Fellow Esk8ers!

12/14/21

A quick update regarding some concerns with the Hoyt St Puck remote control. Nothing lasts forever and the Hoyt Puck is no anomaly. Plastic fatigues and breaks, solder joints atrophy when exposed to repeated stresses. It is important to regularly inspect your Puck to ensure it is flight ready.

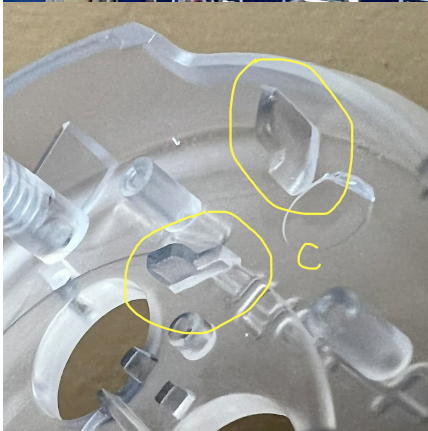
Particularly after a fall but also after aggressive longterm use, these solder joints can fail resulting in a full throttle incident.

Primarily solder joint A but also solder joints B can see wear and stress.

A quick solder top off on these joints is all that is necessary for repair. If you're not confident with your soldering skills, feel free to mail to Hoyt for free repair:

1. Established a 1m drop test protocol with the vendor.
2. Increased solder on all four connections.
3. Added potentiometer support structure (C) to inside of shell.
